RECEIPT DATE: 10-31-17 **ONSITE SEWAGE DISPOSAL SYSTEM** P 502315  
 APPROVAL DATE: 11/2/2017 **PERMIT: CONSTRUCTION** A \_\_\_\_\_  
 PROPERTY ADDRESS: 6513 Heather Glen Way  
 SUBDIVISION: Willow Pond LOT: 10 TAX ID: 05-593283  
 CONTRACTOR: Hatfield's Equipment EMAIL: \_\_\_\_\_  
 CONTRACTOR ADDRESS: ~~6513 Heather Glen Way~~ P.O. Box 519, Annapolis, MD PHONE: 301-496-4289  
 PROPERTY OWNER: Chris Tippett EMAIL: dandahvac@aol.com  
 OWNER ADDRESS: 4347 Aitcheson Road PHONE: 240-294-4470  
 SEPTIC TANK SIZE (GALLONS): 2000 TANK MANUFACTURER: Mayer Bros  
 PUMP MODEL: N/A PUMP SIZE N/A PUMP TANK CAPACITY: N/A

**PLOT PLAN**  
WILLOW POND  
LOT 10 - 6513 HEATHER GLEN WAY  
Plat #21632

**To:** info@fsheri.com  
**Cc:** dandahvac@aol.com  
**Subject:** Willow Pond, Lot 10  
**Attachments:** OSDS Req.pdf; Well & Septic SETBACKS.pdf

**SEPTIC DESIGN PLAN**  
**WILLOW POND**  
LOT 10 - 6513 HEATHER GLEN WAY  
Plat #21632

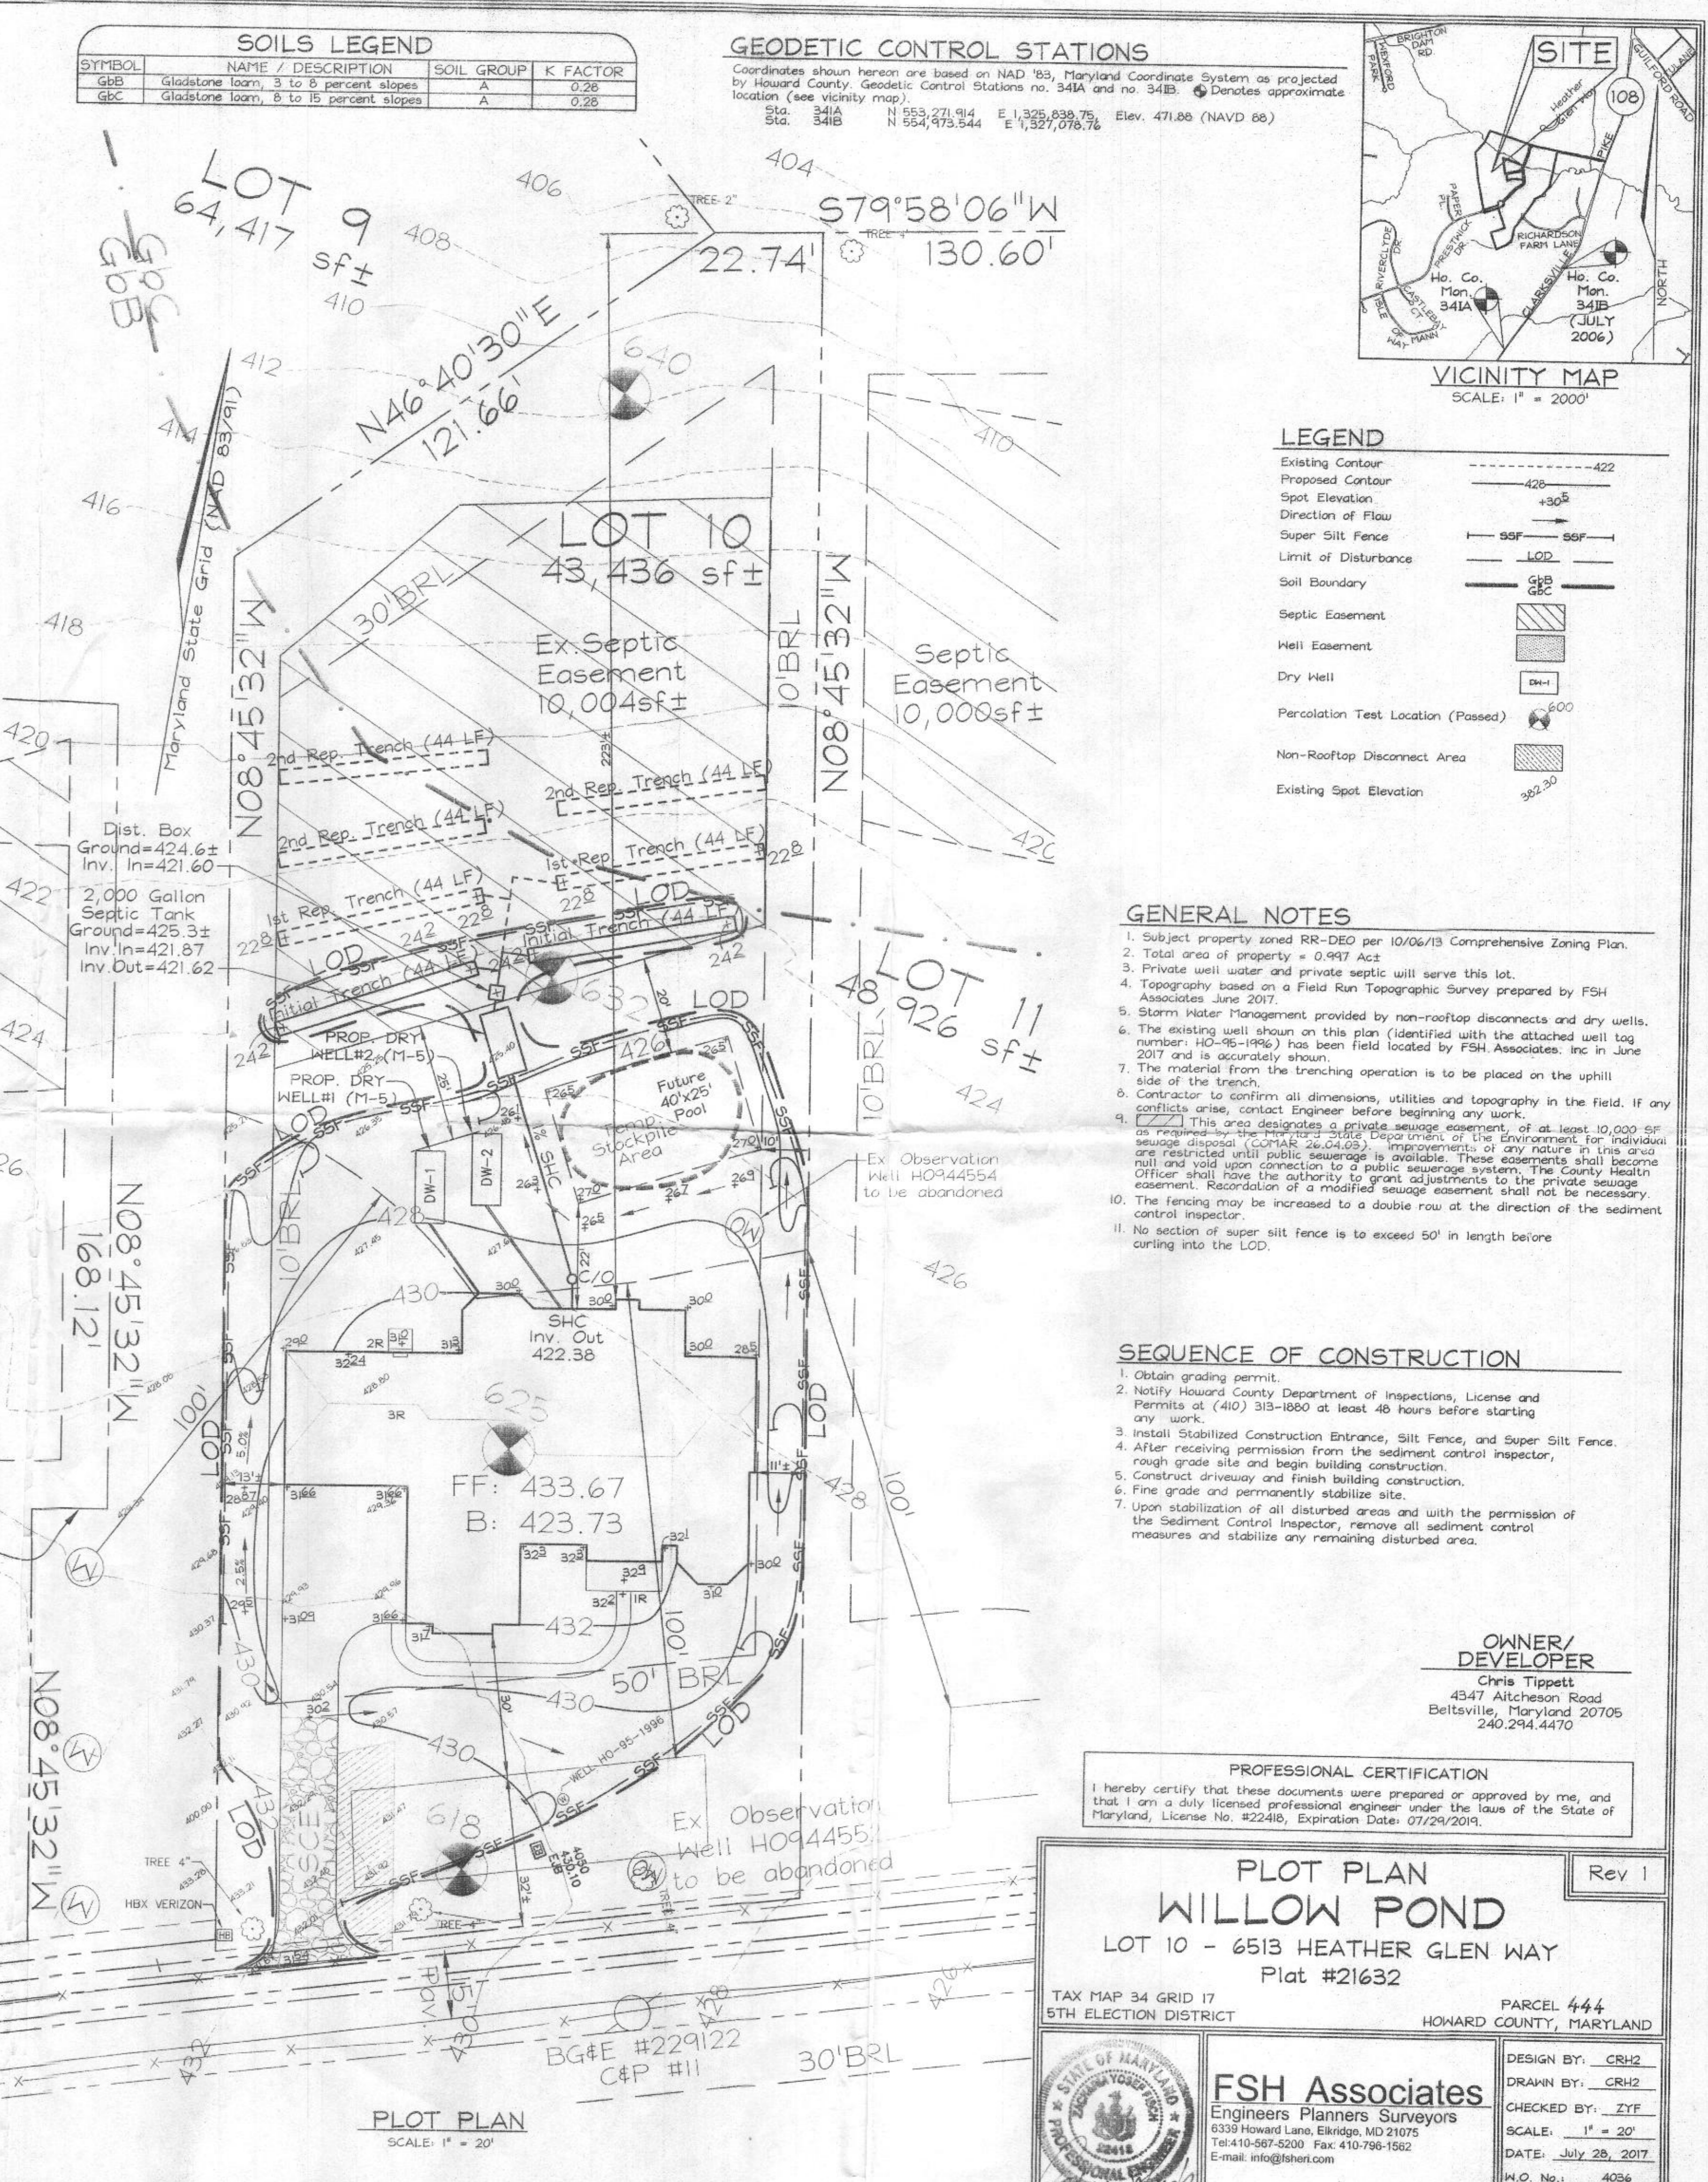
Zach,  
If the location of the drywells change a new plot plan will need to be submitted to DILP showing the changes. This site plan will need to be sent with a filled out transmittal sheet stating changes have been made as per Health request. Once this has been done let me know so I can go onto their site to check for it. This will save some time instead of waiting for a physical copy of the plot plan.

As for meeting the 25' setback from the septic tank to the drywell there are some possible options. If the drywells can be moved to the back end of the property, this would allow for the 25' setback to be met. Another option could be to shift the septic tank over between the pool and the SDA. This would keep the septic tank 10' from the pool and the SDA would remain 20' from the pool. Also the trenches could be shifted inside the SDA to allow room for the tank if necessary. With this option however the Health Dept. will want to see the amount of unusable space (unusable for trenching) minimized.

**PLAN VIEW**  
SCALE: 1" = 20'

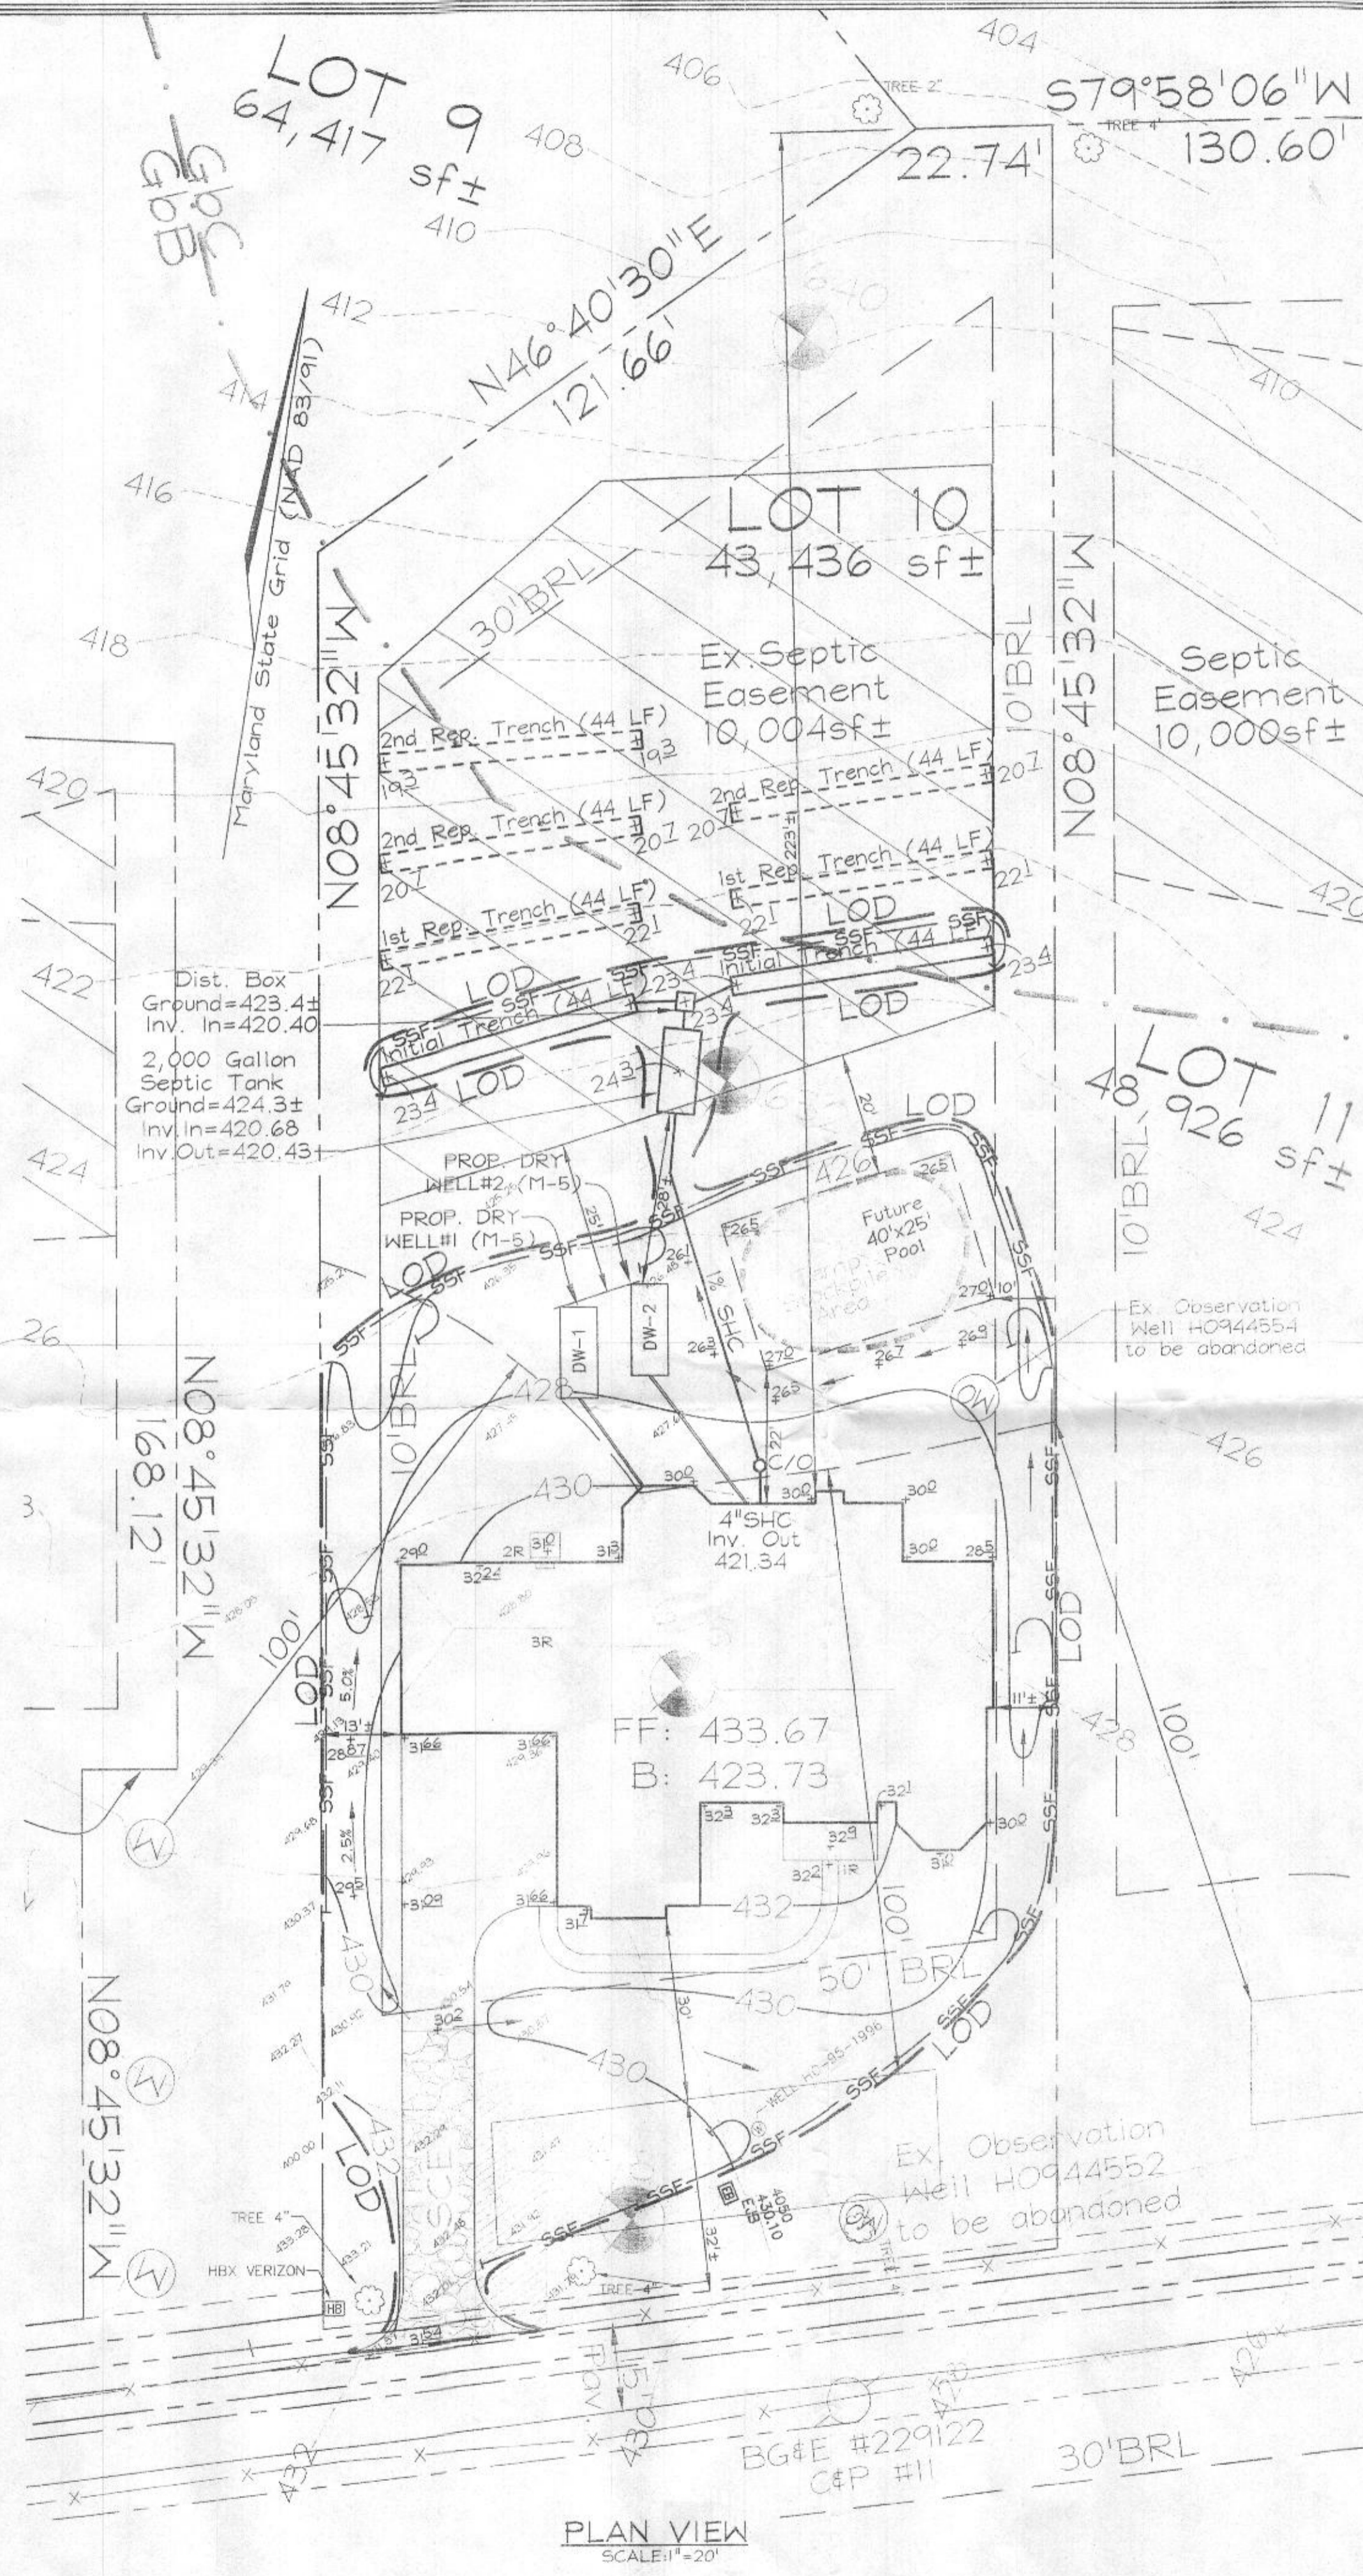
In addition to my last email the septic tank needs to be 25' from the SWM Drywells. I realized I missed adding this in my last email, my apologies. I have included our SWM setbacks sheet that states drywells must be 25' from the OSDS (includes the septic tank). From your answer to my pool question, please add in the water's edge to the plan just to make it clear that it is ten 10' away. If you have any questions let me know.

I have looked over the septic plan for 6513 Heather Glen Way and I have some comments. Is the outline of the future pool showing the edge of the concrete sidewalk or the edge of the water? The septic tank needs to be 10ft from the waters edge of a pool. Also there are some notes missing from the plan that need to be added. I have attached our OSDS requirements sheet which included these notes. I can only redline the first two for you but the last two will have to be redlined by you. If you would rather revise the plan and send new copies to the Health Dept. that would be fine as well. Let me know what you decide. I have included Chris Tippett in this email as per his request.

P.S. Note #3 does not need to be added since this is a gravity system. Note #4 must include who field verified the well location.

Per Chris ,the outline of the pool, shown on the plan, is to the concrete walk and not water edge. The water's edge will be set 10 feet from the septic tank.

I will drop off, to your attention, later today, a revised plan with the requested notes.
